**AWPR
A944
SOUTH KINGSWELL ROUNDABOUT
AND ASSOCIATED ROADS
ABERDEEN**

STAGE 3 ROAD SAFETY AUDIT
(SPA Ref No: 4021)

Roads Authority: TRANSPORT SCOTLAND

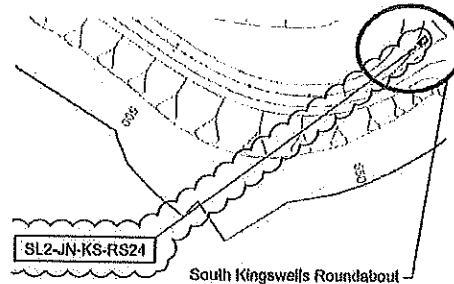
It was noted that on the splitter island on A944 South Kingswell Roundabout / Kingsford Gairnlea Road no bollard had been provided at the interface of the circulatory carriageway and the exit arm

There was no permanent signing provided on the splitter island although the design provides for a bollard with left aspect for northbound traffic approaching the roundabout on the Kingsford Gairnlea Road. Temporary direction signs are currently provided on the splitter island.

It is recommended that a bollard with blank face be provided between the circulatory carriageway and the Kingsford Gairnlea Road. It is further recommended that the as designed bollard be provided on the splitter island for northbound traffic.

In addition, it is recommended that the designer reviews to need to provide a fingerpost direction sign on the splitter island.

Recommendation accepted. A bollard with a blank face will be provided between the circulatory carriageway and the Kingsford Gairnlea Road. We can also confirm that the bollard on the splitter island for northbound traffic will also be provided as per the design.

A signage strategy was developed with Transport Scotland, Aberdeenshire Council and Aberdeen City Council. This included all advanced directional signage including fingerpost directional signs. As part of this strategy, it was considered that finger post directional signs were not required for the splitter island on the A944 South Kingswell Roundabout / A944 Westbound exit arm

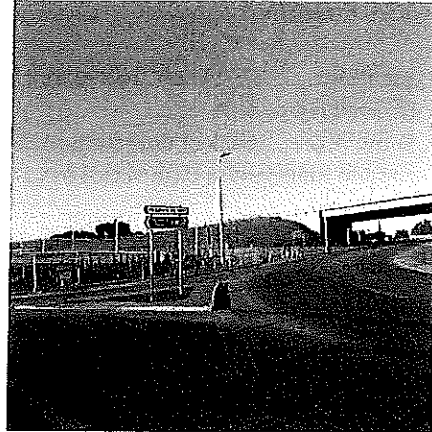
It was noted that on the splitter island on A944 South Kingswell Roundabout / A944 westbound exit arm no bollard had been provided at the interface of the circulatory carriageway and the exit arm

A permanent non – illuminated fingerpost sign had been provided on the splitter island.

It was mentioned on site that the sign seen in the picture opposite had already been struck by a vehicle.

It is recommended that a bollard with blank face be provided between the circulatory carriageway and the A944 westbound exit arm.

Recommendation accepted. A bollard with a blank face will be provided between the circulatory carriageway and the A944 Westbound exit arm.
